FEBRUARY 8, 2019 USC CLASSROOM ENHANCEMENTS 2019 FOR COKER 510 PROJECT# 50003348-2,H27-Z341

ADDENDUM #2

1. Electrical Drawing Sheet E101. Electrical Plans.

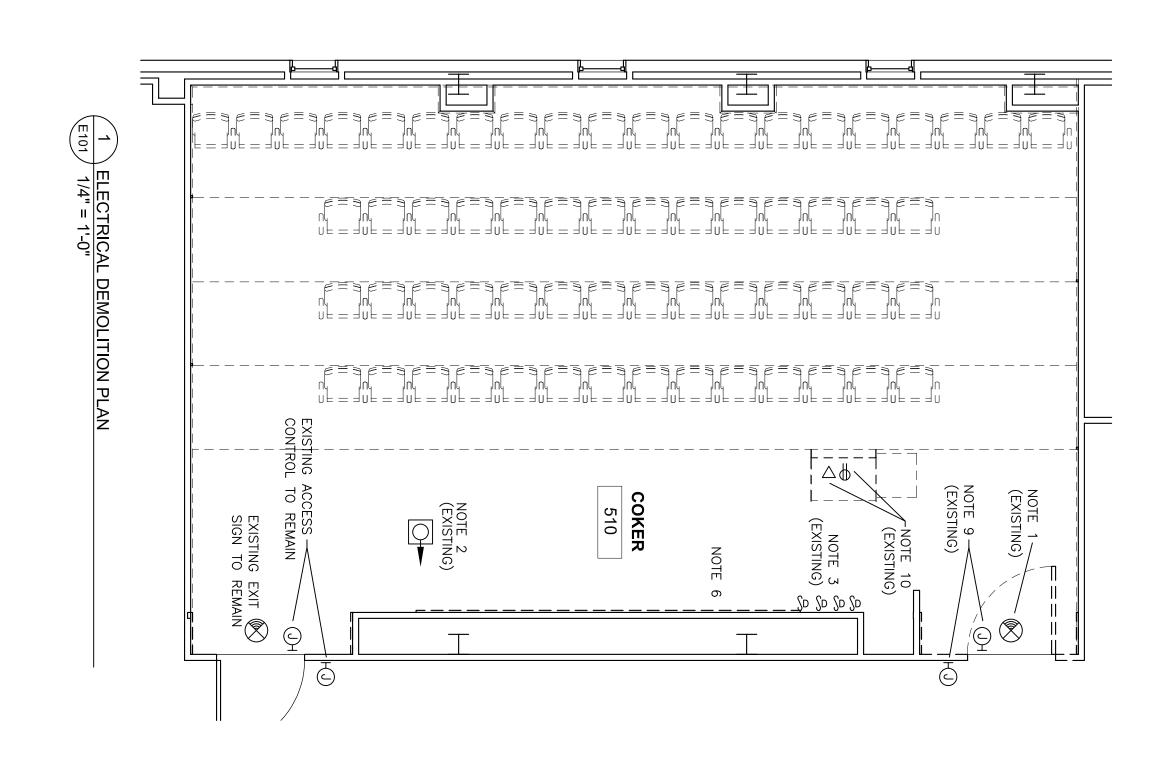
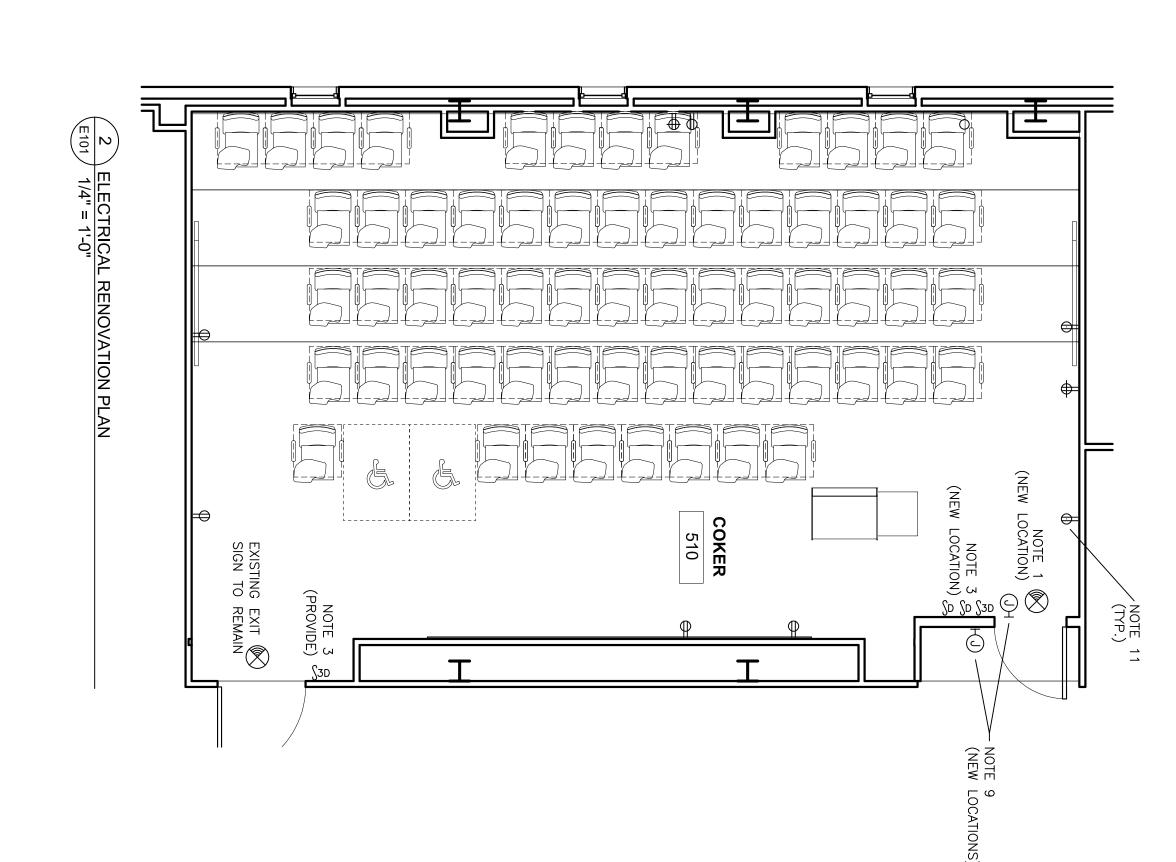
3 LIGHTING RENOVATION PLAN E101 1/4" = 1'-0" : ALTERNATE I NO.1 NOTES

PART OF ALTERNATE NO. 1 PRICING, PROVIDE REPLACEMENT LED LAMPS (GREENCREATIVE# 11.5T8/4F/835/EXT OR APPROVED EQUAL) AND ASSOCIATED DRIVERS (GREENCREATIVE# 15T8T5HEDRIVER/4CH OR APPROVED EQUAL). PROVIDE NEW DIMMER SWITCHES (LEVITON# IP710—LFZ OR APPROVED EQUAL). NOTE: IT IS IMPERATIVE THAT THE LAMPING, DRIVER AND DIMMER CONFIGURATION IS COMPLETELY COMPATIBLE. ANY APPROVED EQUAL COMBINATION SHALL BE SUBMITTED TOGETHER AS ONE SYSTEM. REMOVE ALL EXISTING LAMPS AND BALLASTS FROM EXISTING FLUORESCENT LIGHTING FIXTURES. ALTERNATE NO. _

REUSE OR PROVIDE CONDUCTORS (BOTH POWER AND LOW VOLTAGE SWITCH LEG) IN CONDUIT TO MAKE EXISTING RETROFIT FIXTURES FULLY OPERATIONAL WITH 10% DIMMING. PROVIDE PLENUM RATED LOW VOLTAGE CONDUCTORS (PURPLE AND GRAY) AS REQUIRED.

RELOCATE POSITION OF TWO (2) EXISTING DIMMER SWITCHES TO LOCATION ADJACENT TO RECONFIGURED DOORWAY AND PROVIDE THREE WAY DIMMER SWITCHES AT BOTH DOORWAYS. PROVIDE WHITE DEVICES FOR ALL OF THESE. THE FRONT 2'x4' FIXTURES SHALL BE CONTROLLED WITH THREE WAY DIMMER SWITCHES. EXTEND OR PROVIDE NEW SWITCH LEGS AS REQUIRED. PROVIDE NEW PERMANENT LABELS ON DIMMERS — "FRONT", "REAR" AND "LECTERN."

REMOVE EXISTING ELLIPTIPAR LIGHTING FIXTURE AND ASSOCIATED DINSWITCH (ONE OF THE FOUR DIMMER SWITCHES SHOWN ON PLAN). RELOCATE EXISTING EXIT SIGN TO ACCOMMODATE DOOR SW RECONFIGURATION. EXTEND CIRCUIT AS REQUIRED.
